TOWN OF JACKSON PLANNING & BUILDING DEPARTMENT

TRANSMITTAL MEMO

The applicant is submitting a request for a Zoning Compliance Verification Minor Deviation - Continuation for 610 E. Hall, Legally known as PT. LOTS 12,13, BLK. 4, HALL 2 (T-65I FILED 9/5/12) PIDN: 22-41-16-34-1-28-008

RE: Final Letter
Item P19-085
Variance – Curb Cut

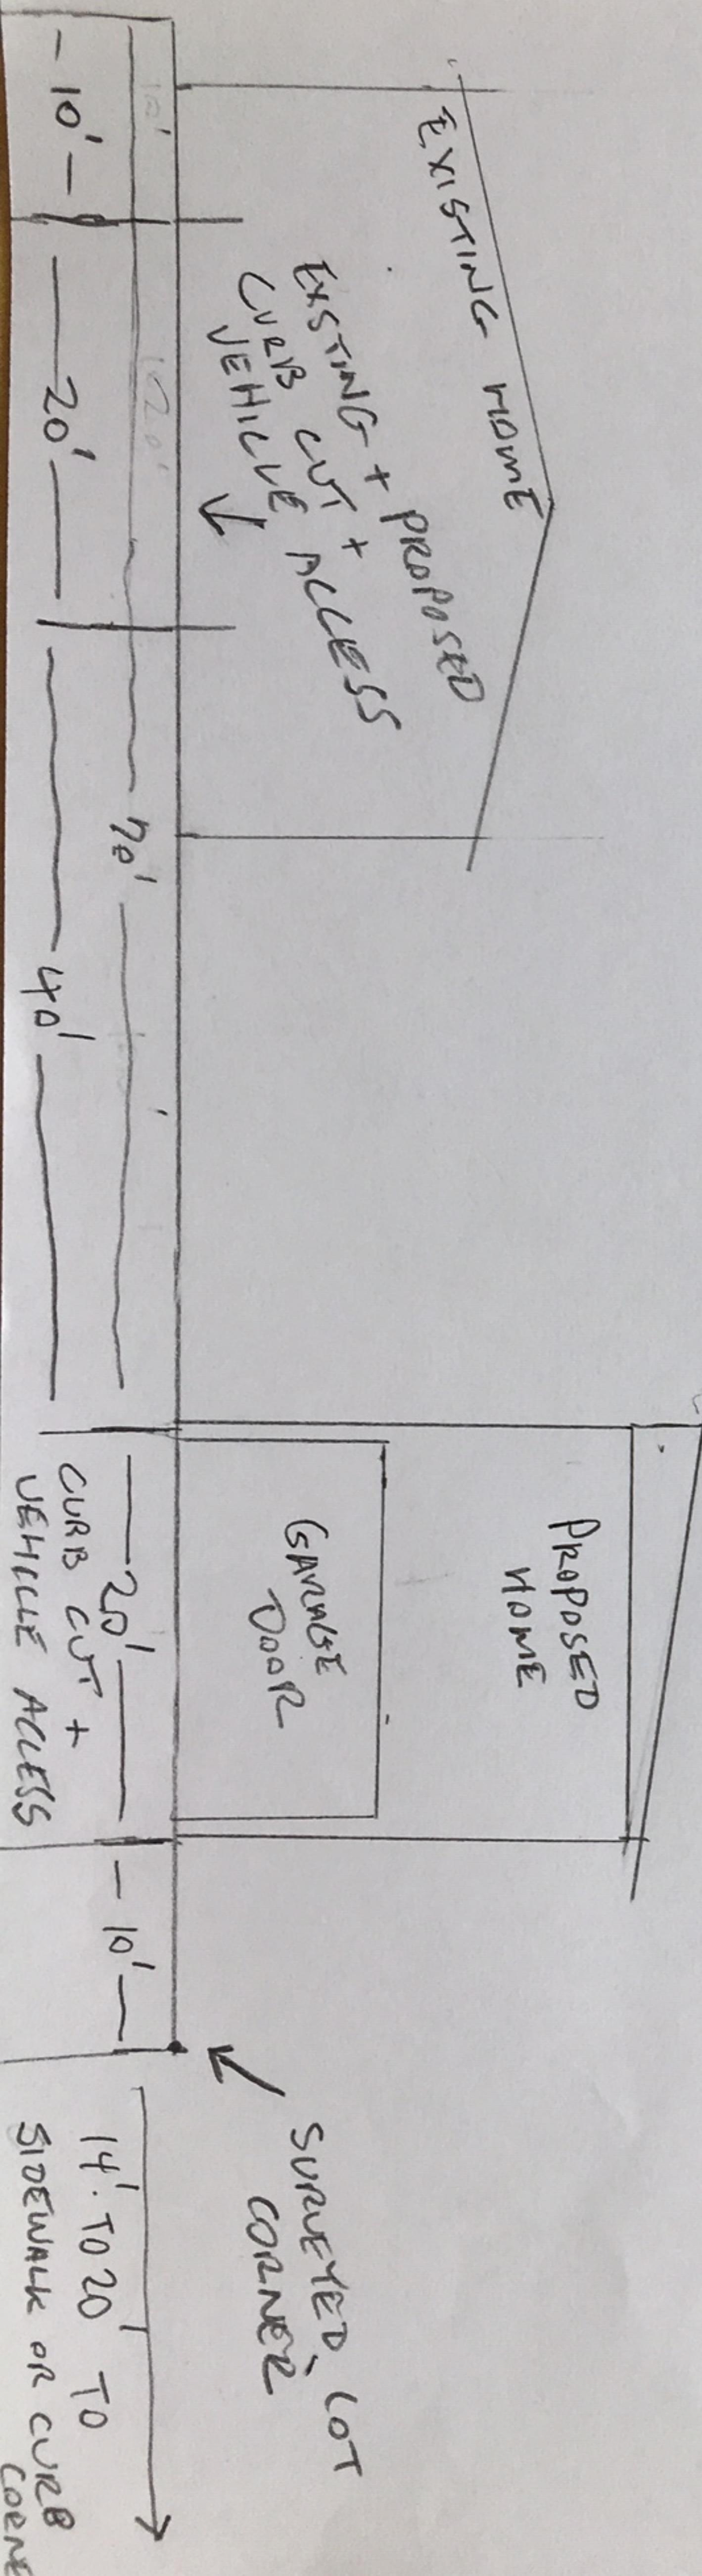
- Ensure that the driveway is graded to an elevation that will allow for a possible future sidewalk along Hall St. The elevation should be such that the sidewalk could be a detached continuous sidewalk (so that the sidewalk is continuous across the driveway across at the same height or higher than the back of curb, approximately 6").

1. LDRs 2.2.6.B.2 Vehicle Access – Curb Cut Width Max: 20' or 40% of Lot Frontage, whichever is less.
2. LDRs 7.6.3.F.3 – Access Points: Driveway entrances shall not be allowed on arterial or collector streets unless no other access option exists. Driveways shall not be located in less than 50 feet from the curb-line on a intersecting street. Driveway entrance dimensions and construction details shall be in accordance with the driveway standards.

1. The number of curb cuts shall be limited to two (2) with a maximum width of twenty (20) feet.
2. Setback from the surveyed corner should not be less than the ten (10) feet shown on the propose plans.
3. Development of the lot frontage should consider the Hall Ave. frontage as two (2) fifty feet wide lots and conform to the development standards as though there was two lots.
4. No vehicular access to Redmond Street is allowed.
